14 OXFORD - GARAGE

**HISTORIC PRESERVATION COMMISSION STAFF REPORT**

<b>Address:</b>	14 Oxford Street, Chevy Chase	<b>Meeting Date:</b>	<del>12/29/2006</del> 5/09/07
<b>Resource:</b>	Contributing Resource Chevy Chase Village Historic District	<b>Report Date:</b>	12/13/2006 5/02/07
<b>Applicant:</b>	J.W. Rayder (Mike Sullivan, Architect)	<b>Public Notice:</b>	12/6/2006 4/25/07
<b>Review:</b>	HAWP	<b>Tax Credit:</b>	N/A
<b>Case Number:</b>	35/13-07Q	<b>Staff:</b>	Michele Oaks

**PROPOSAL:** Alterations to detached garage and construction of rear porch

1 LEFT ELEVATION - REAR PORCH  
A3.06 1/2"=1"

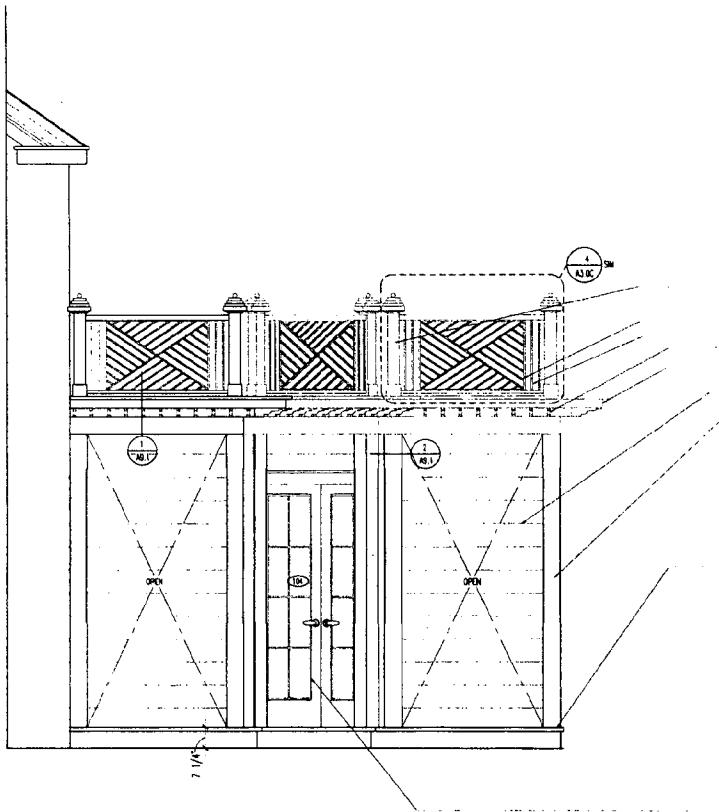
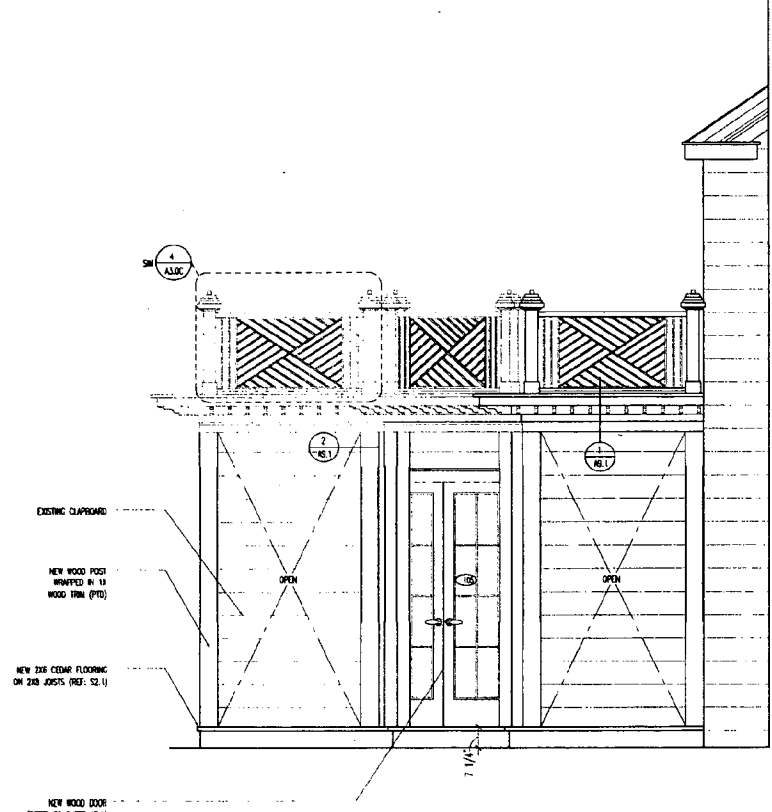
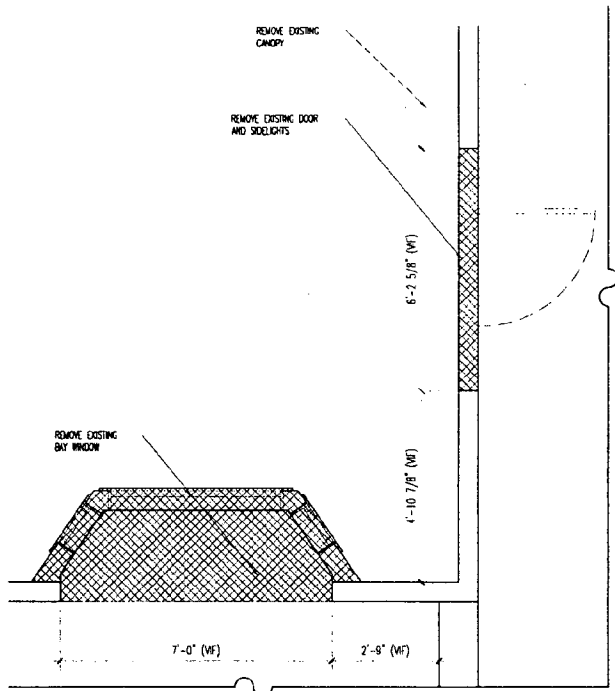
1. The applicant will contact the Chevy Chase Village arborist to discuss if a tree protection plan is needed for this project. If required, the plan will be implemented prior to any work beginning on the property.
2. The detail for the proposed cedar flooring for the covered porch will be tongue and groove.
